Airways New Zealand updated submission to the Civil Aviation Authority's 2018 Nelson and Marlborough Airspace Review

Prepared by: John Wagtendonk
Policy, Standards and Safety Improvement
Airways New Zealand

UPDATED 12 February 2018

Below is the Airways New Zealand (Airways) updated submission to the CAA 2018 Nelson and Marlborough Airspace Review. This submission replaces our earlier submission dated 11 January 2018.

Diagram 1 Draft v9 NS CTA and CTR

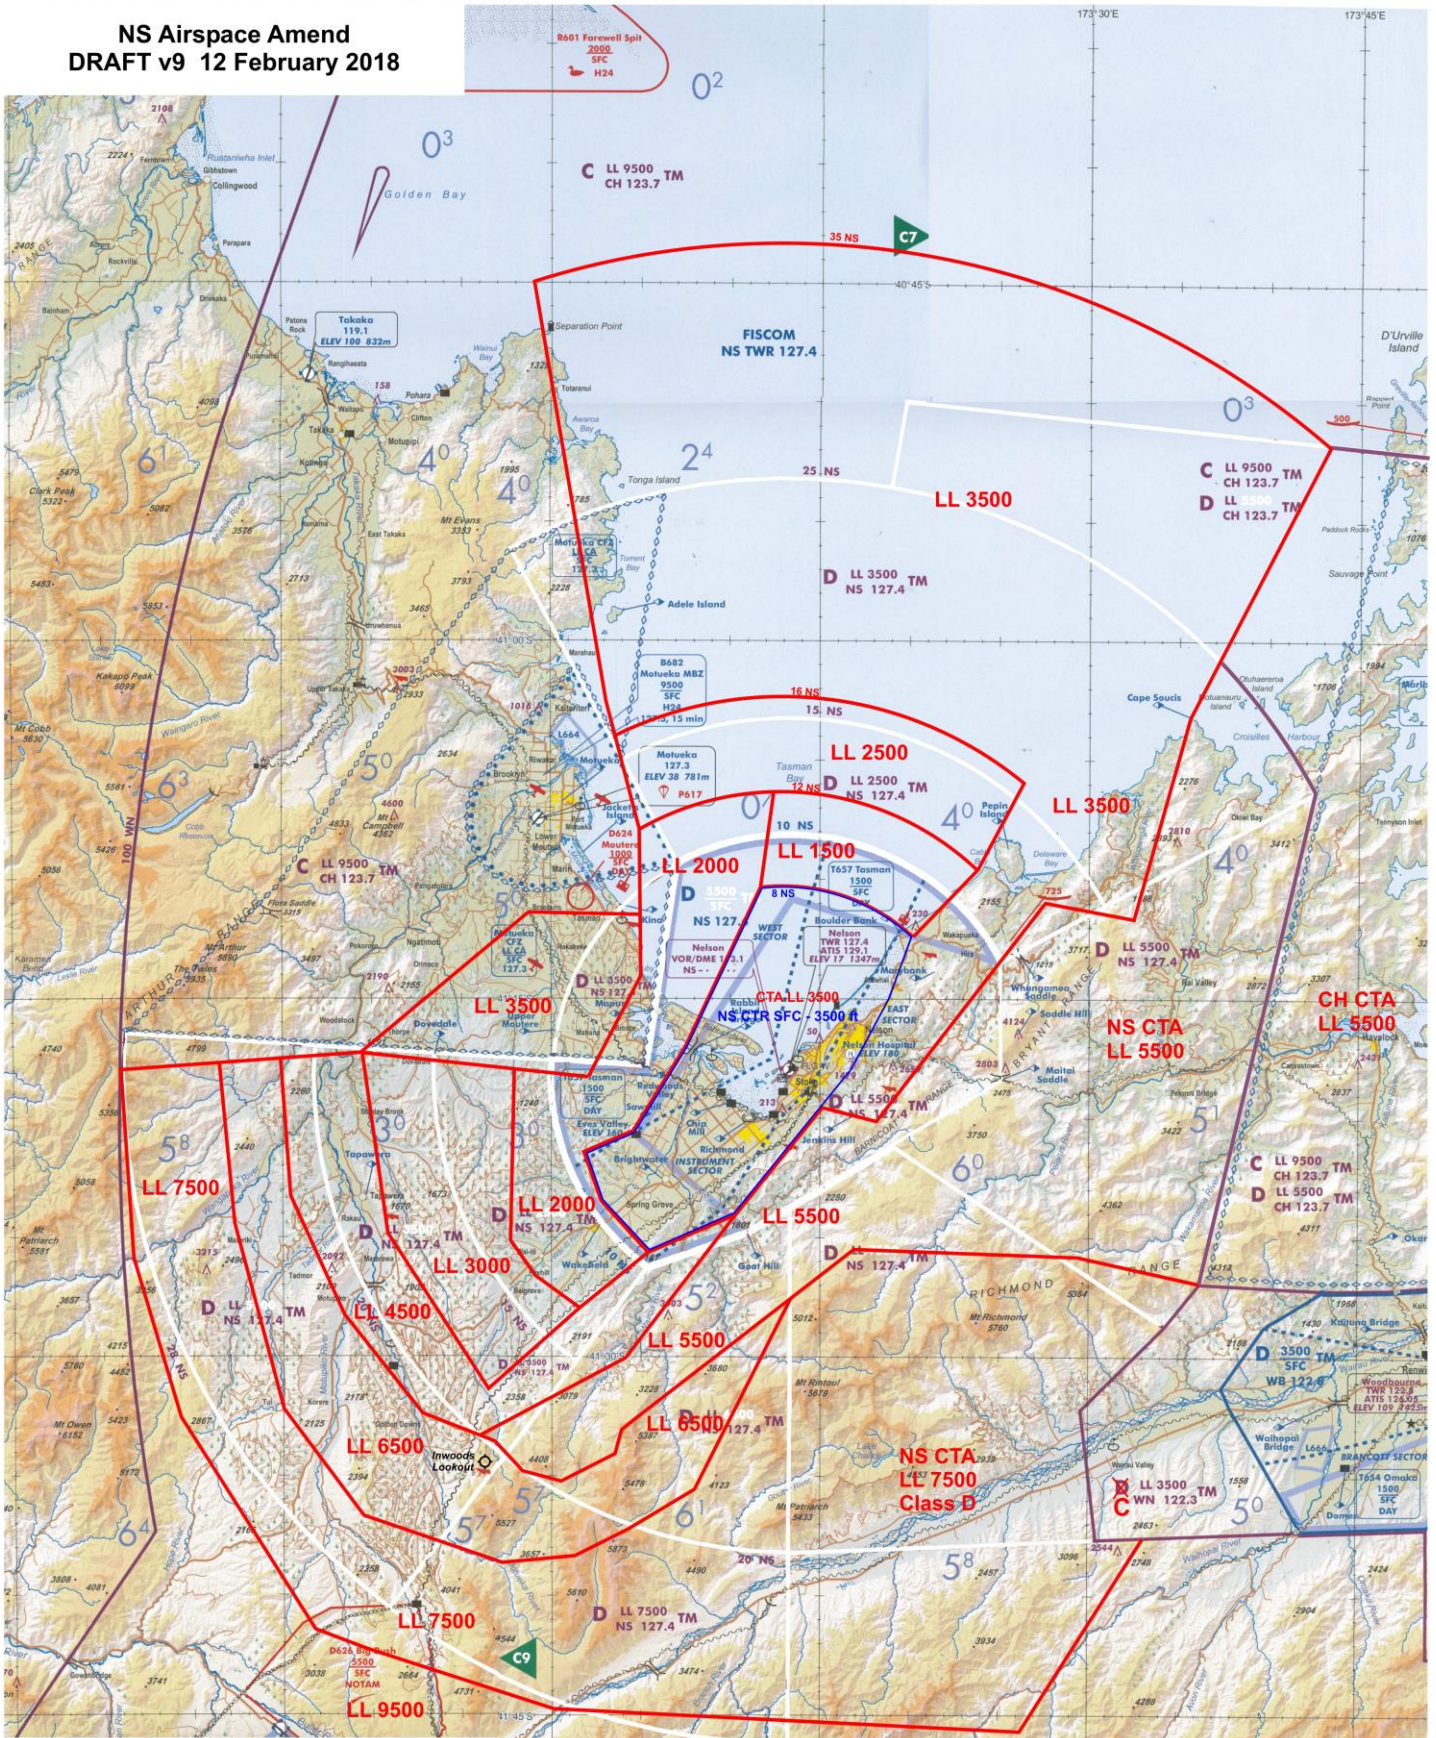
Diagram 1 below depicts the Airways proposed amended Nelson control zone (NS CTR) and Nelson control area (NS CTA). The white lines are the existing airspace boundaries that would be deleted.

- Transit lane T657: northern and western portions to be disestablished - southern portion to be amended.

Diagram 2 Close up of Draft CTR

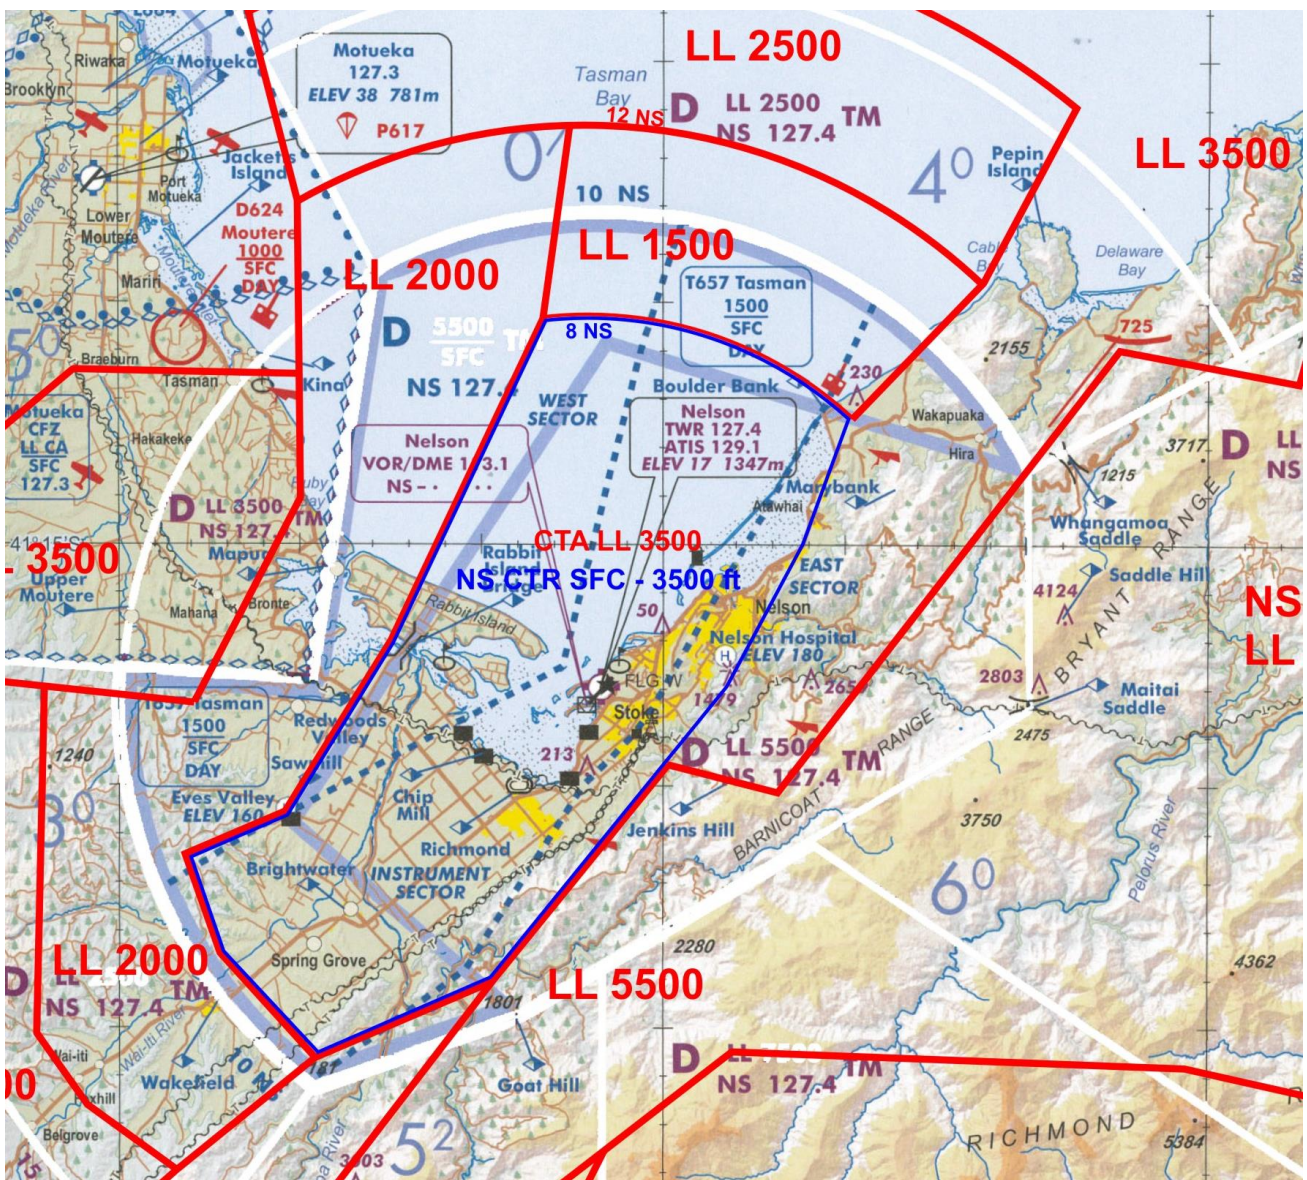
Diagram 2 below is a close up of the draft NS control zone (CTR) – the thin blue line. Note the significant reduction in the CTR to the east of Nelson airport. The eastern boundary of the draft CTR lies 2 NM to the east of the airport. This would provide sufficient protection to light aircraft operations in the non-standard circuit to the east.

The western boundary of the draft CTR provides for containment of the Cat A, B and C circling areas for the IFR approaches. Unfortunately, the western boundary can not be brought closer to lie over Rabbit Island bridge as doing that would infringe the Cat C circling area (4.2 NM radius from RWY 02/20 thresholds).

Diagram 2 depicts the existing transit lane T657. The Airways submission is that the northern and western portion of the transit lane will be disestablished but a modified transit lane will be retained in the southern portion of the CTR. Refer to Modified transit lane paragraph next page.

The instrument sector depicted on Diagram 2 will be modified slightly to correctly fit the requested CTR and approaches.

Diagram 3 detailing infringement of RNAV approach by T657

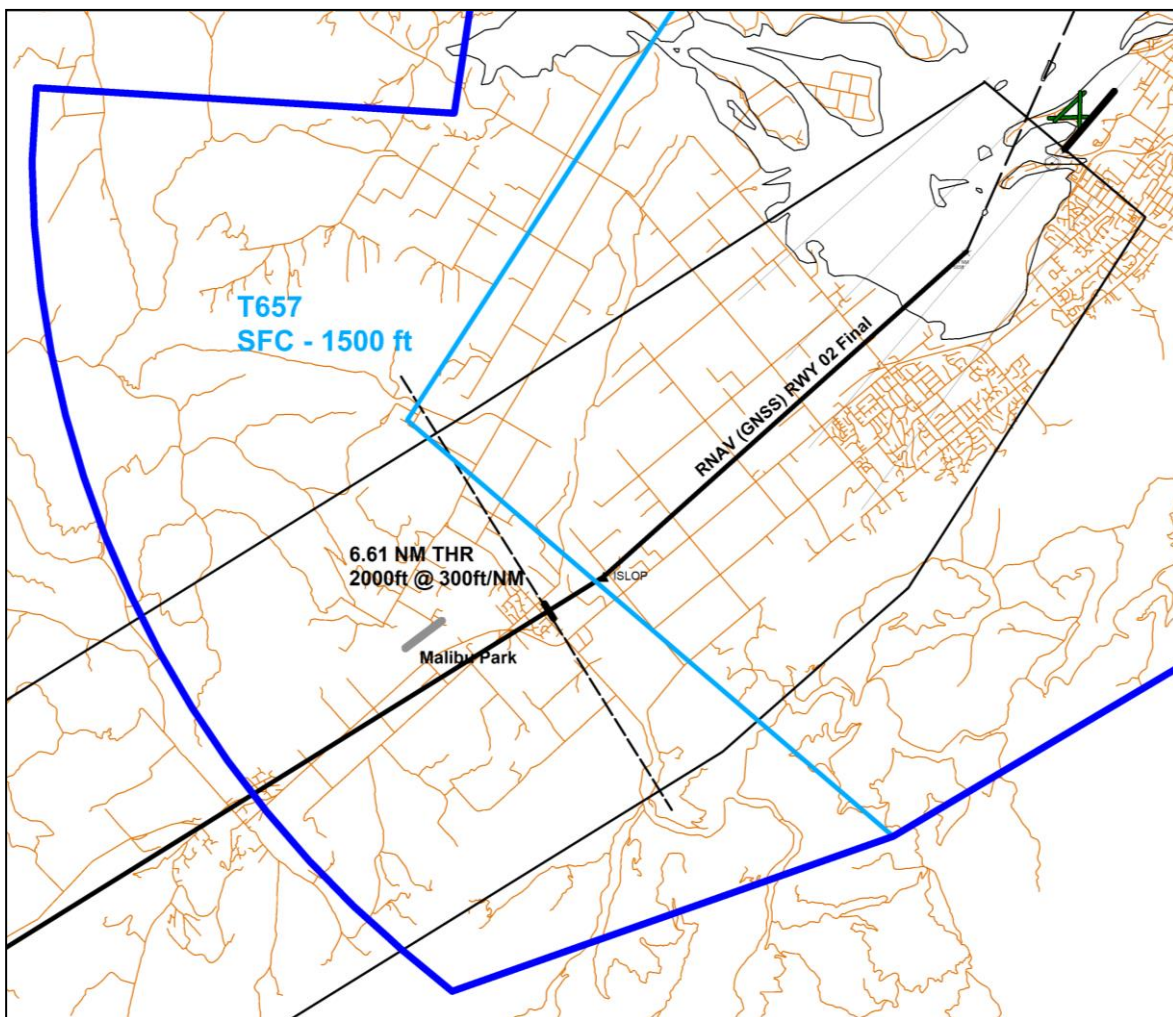
The existing transit lane T657 (SFC to 1500 ft) infringes the VOR/DME C and RNAV (GNSS) RWY 02 approaches. Diagram 3 below depicts the inbound legs of the RNAV (GNSS) RWY 02 approach along with the lateral containment fan to the left and right of the final approach track. Also marked is the point on the approach track at 6.61 NM where the airspace containment profile of 300 ft per NM from runway threshold descends through 2000 ft.

Inside 6.61 NM from the threshold, the airspace containment profile for the approach is lower than 2,000 ft and is less than the minimum 500 ft above the transit lane. Therefore, the approach is not correctly contained in regards to the transit lane – the transit lane infringes the containment of the approaches.

For correct airspace containment of those approaches, T657 would need to be reduced in size – horizontally and/or vertically.

Diagram 4 detailing transit lane option 3 – inner boundary does not follow prominent geographical features

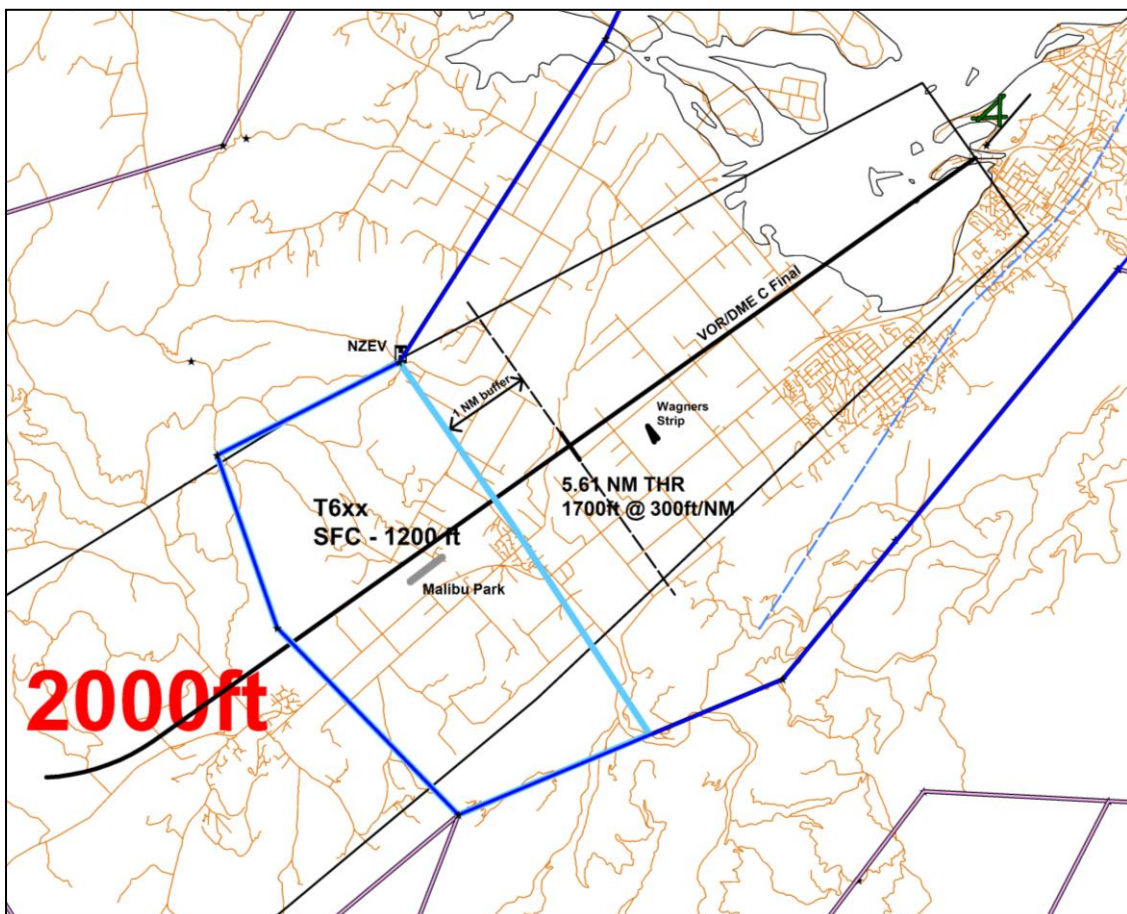
1. to retain the current boundary of T657 the upper limit would need to be reduced to 900 ft AMSL;
2. to retain the 1500 ft upper limit, the inner boundary of T657 would need to be moved west to lie 1 NM west of Brightwater, over the top of Malibu Park airfield;
3. Diagram 4 depicts an option with a 1200 ft upper limit with the inner boundary through Brightwater – note that the inner boundary does not follow prominent geographical features and therefore a 1 NM buffer needs to be applied; and
4. Diagram 5 depicts an option with a 1400 ft upper limit with the inner boundary following prominent geographical features being Eves Valley Rd, short sealed road, metalled road, Waimea West Rd, Ellis St, River Terrace Rd and Lee Valley Rd.

Diagram 5 detailing transit lane option 4 – inner boundary does follow prominent geographical features (roads)

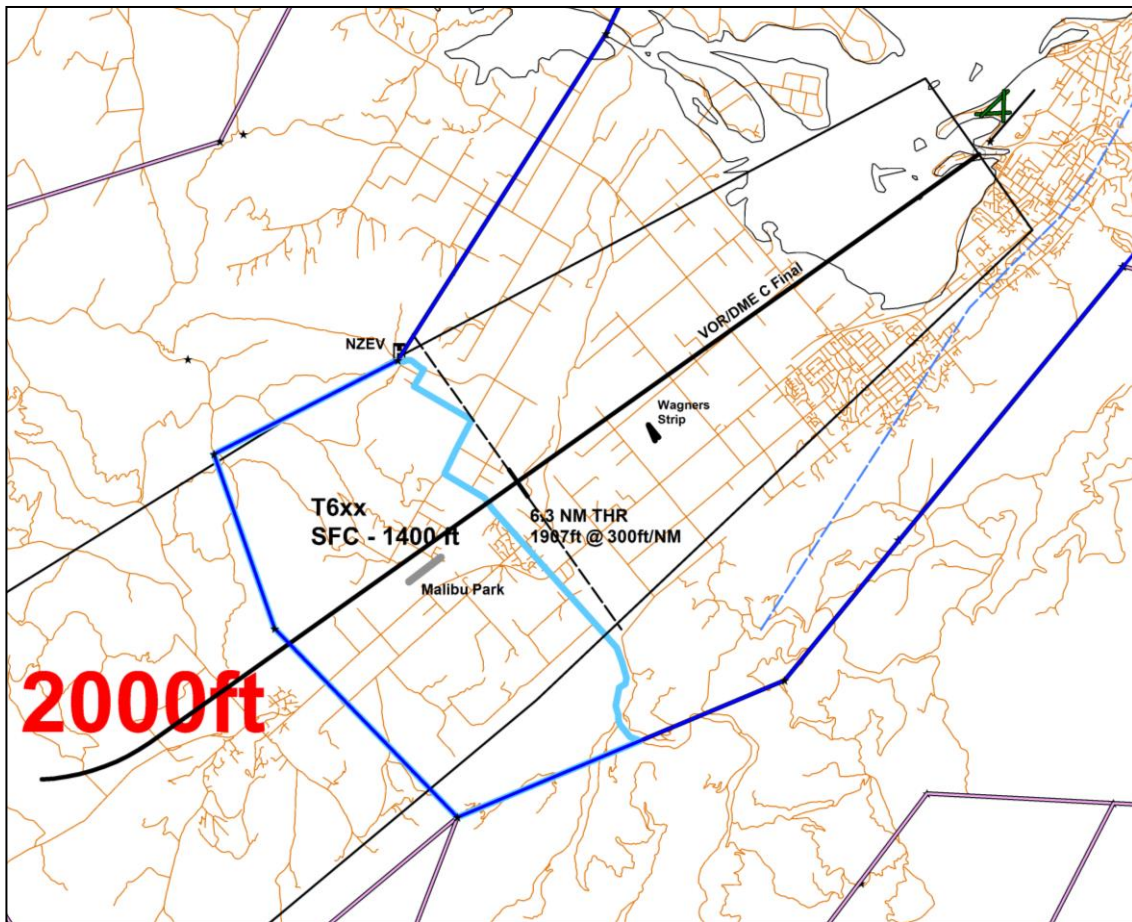
At the 20 October 2017 Airways PBN consultation meeting held at Nelson, the feedback from attendees was that option 4 should be adopted.

This option is also suitable for the RNAV approach and departures – although the departures would need to specify a slightly steeper gradient than 5% to 1900 ft to clear the 1400 ft upper limit of the transit lane.

In light of the feedback, the Airways submission is for the retention of the southern portion of T657 with modified boundary as per option 4/Diagram 5 and upper limit lowered to 1400 ft AMSL.

Diagram 5 Google Earth image showing the location of Eves Valley heliport (NZEV), the draft CTR (blue line) and the inner boundary of transit lane option 4 (light blue line)

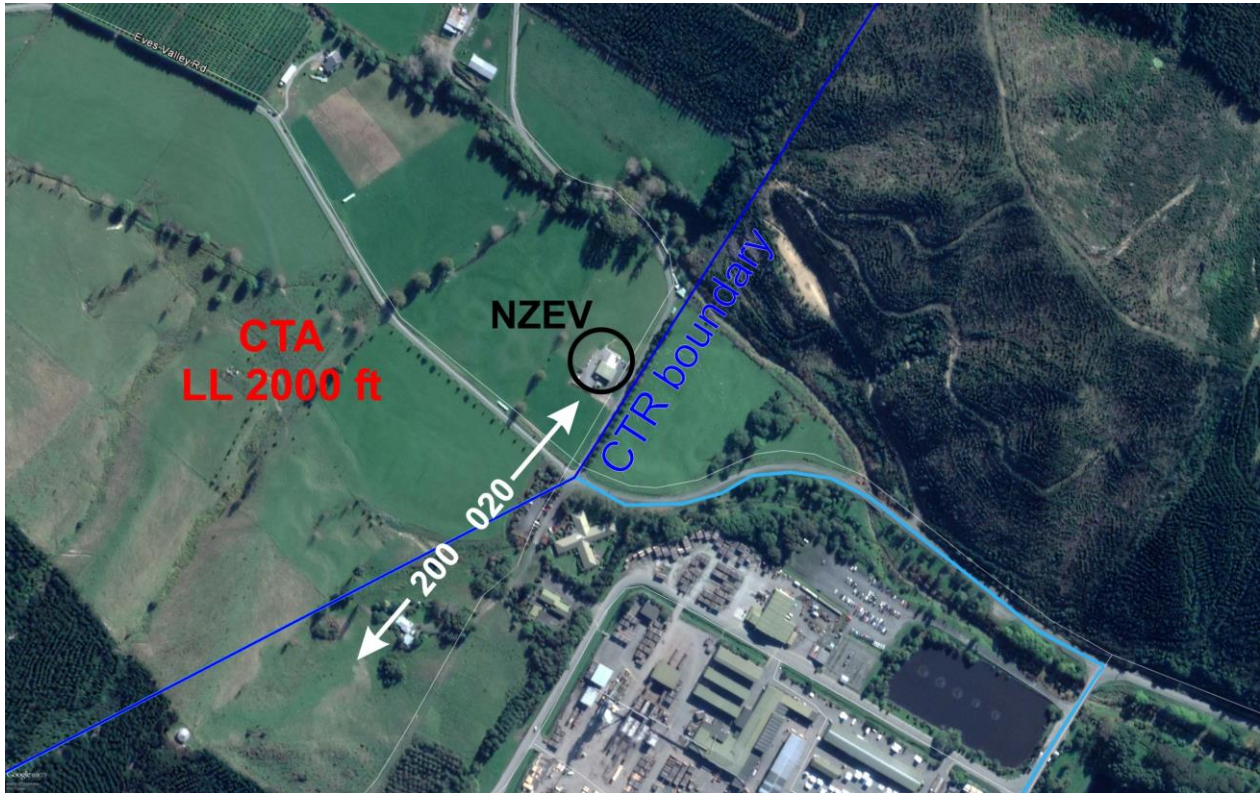
As depicted on the Google Earth image below, the Eves Valley heliport (NZEV) is just outside the requested CTR.

If the requested CTR is adopted, Airways suggests to the operator that the extent of the NZEV APCH/DEP Sector should be reviewed – the current 200° 020° track goes inside the CTR.
